**Item No.**  
**Design Review Committee**  
**July 30, 2020**

**SUBJECT:** **Case 22708: Substantive Site Plan Approval for 1325 Lower Water Street, Halifax**

**1 BUILDING ELEVATION - EAST**  
 DP3.2 SCALE: 1:200

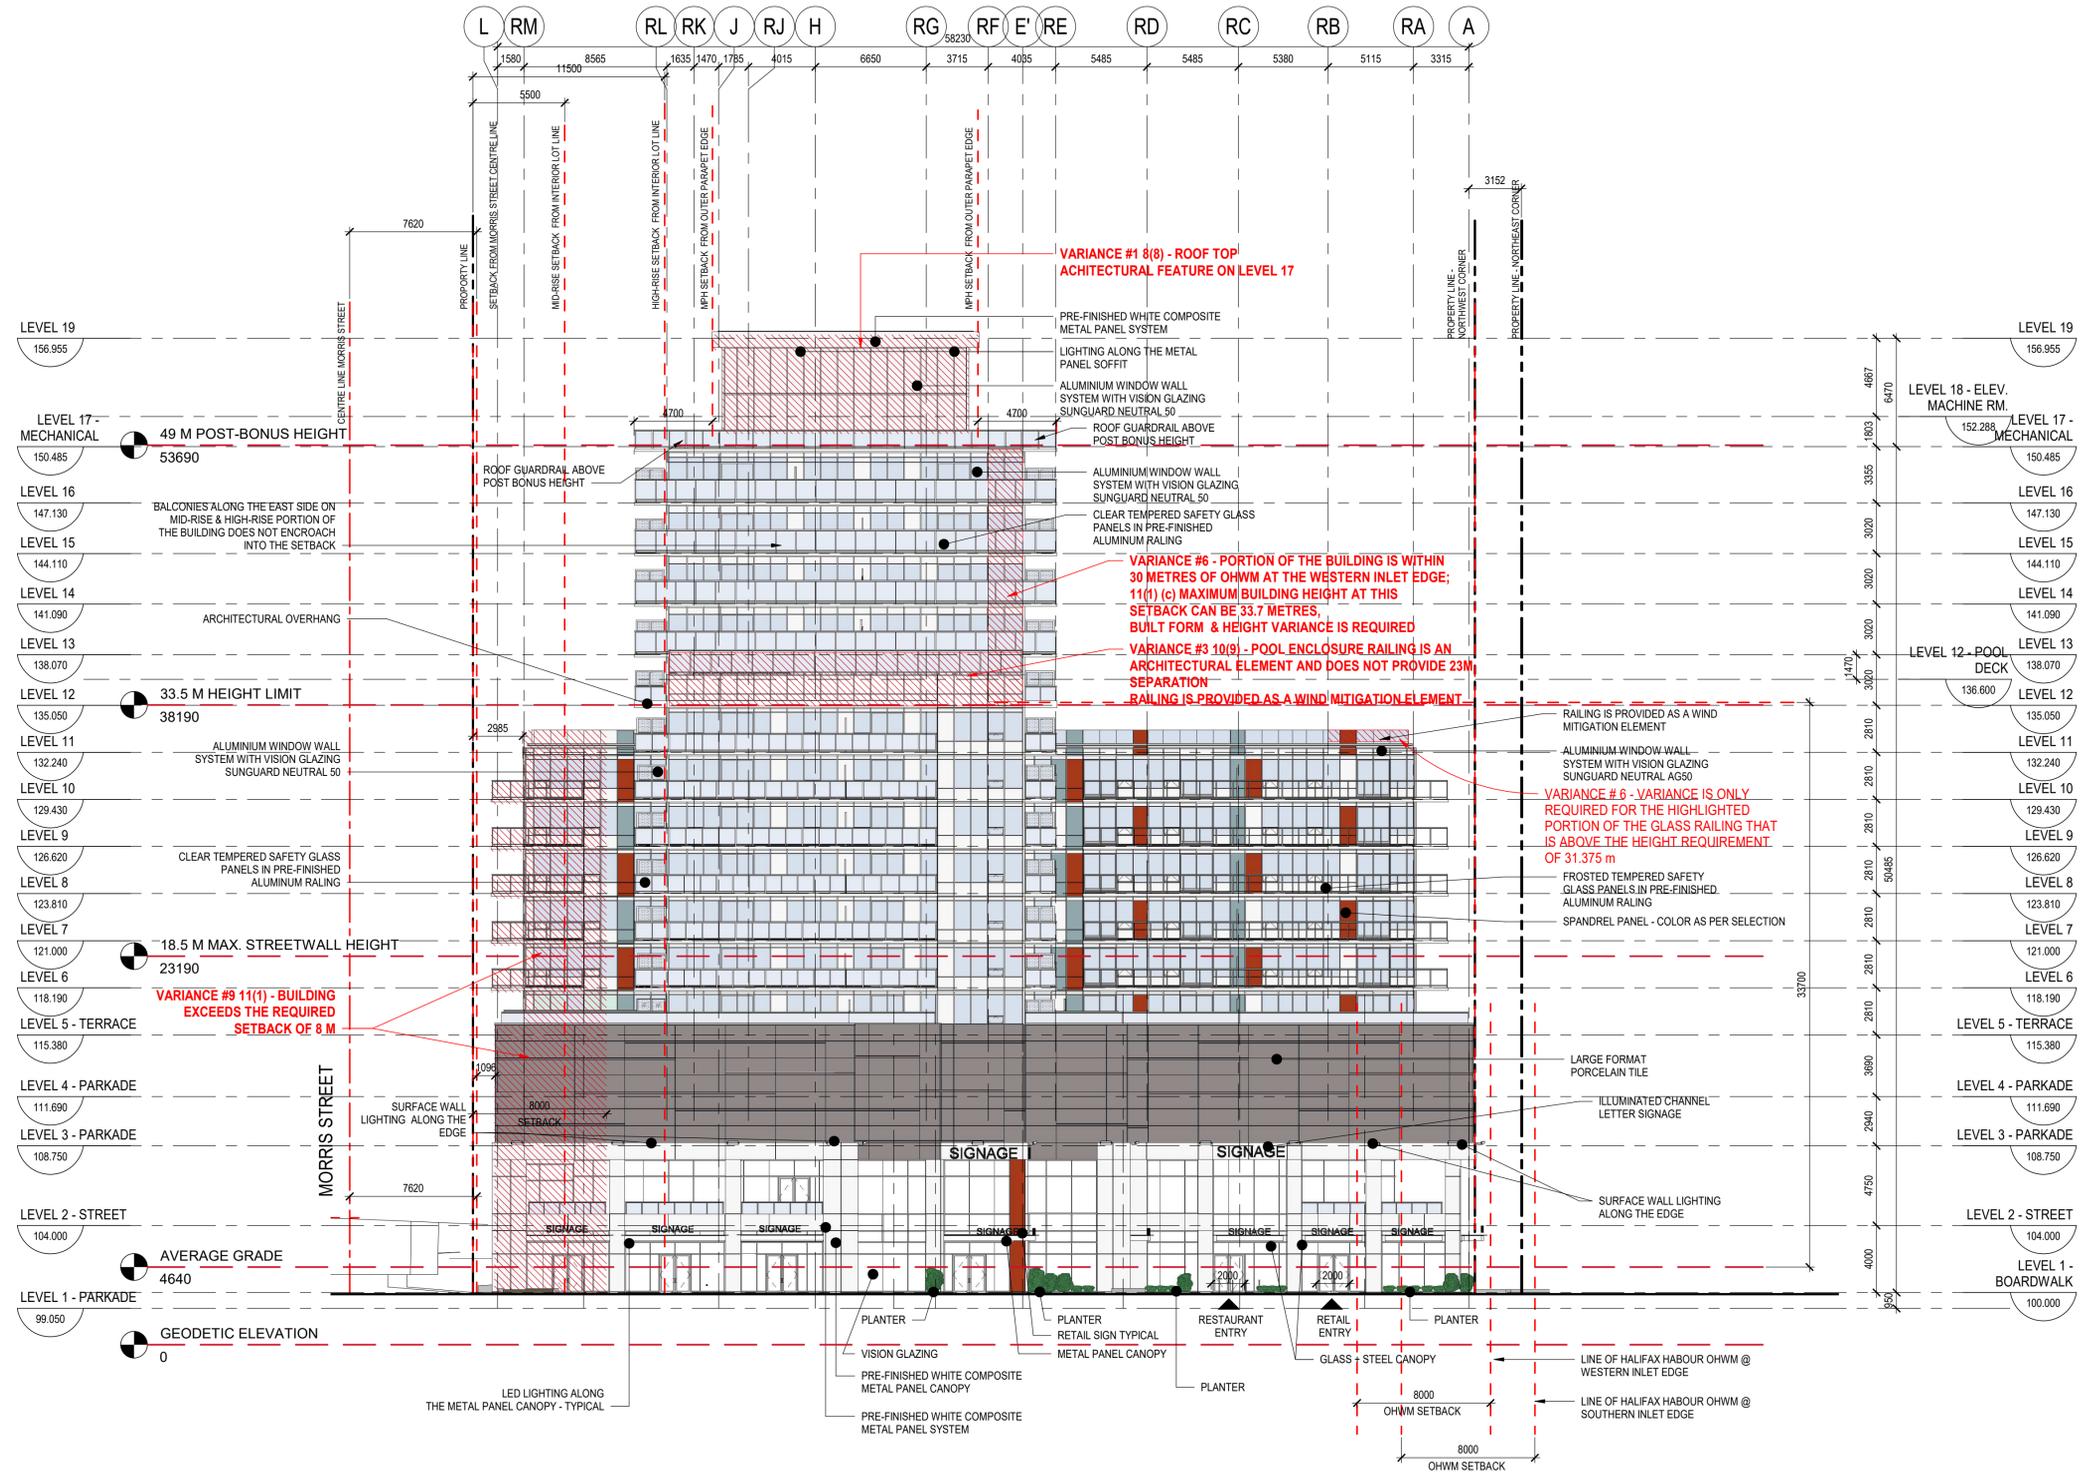
Staff advise the proposed streetwall is complete and consistent but does not provide either visual or physical access from the east to the water. The design of the streetwall is a relatively blank facade with limited activity. Staff note the presence of a door at the northwest corner of the building does help provide animation to the street, but this animation is generally absent over the rest of the streetwall. The proposal has provided only 2 entrances on the west façade along a 55m frontage. Additionally, the Lower Water Street elevation is largely planters for approximately 37 metres of the frontage. The Design Manual also requires visual and physical access to the harbour, from Lower Water Street. The building does not provide this access as it is built out completely at the street property line.

Section 3.2.1f requires that *"streetwalls should have many windows and doors to provide eyes on the street and a sense of animation and engagement."* Windows and doorways have been used at the corners of the building on Lower Water Street and provide an appropriate level of transparency at those locations, but there is a large stretch of the proposed frontage that remains inactive and without doors or windows. Discussions with the developer held through the application process resulted in a door being included towards the northwest corner of the building along the Lower Water Street elevation. While this is recognized as an improvement to the proposal, the majority of this prominent elevation remains not only

Section 3.2.5a seeks to “*maintain active uses at-grade, related to the sidewalk, stepping with the slope. Avoid levels that are distant from grade.*” In response to the sloping condition, the building has an entryway at the northeast corner to activate that section of the street level. While this does help address the issue at that corner, large sections of the Lower Water Street frontage have not been activated. Approximately 37 m of street frontage are without windows or doorways, with the majority of the window placement occurring at over 2 m in height. The proposal does include planters to break up the space, but large stretches of this important street frontage remains without activation.
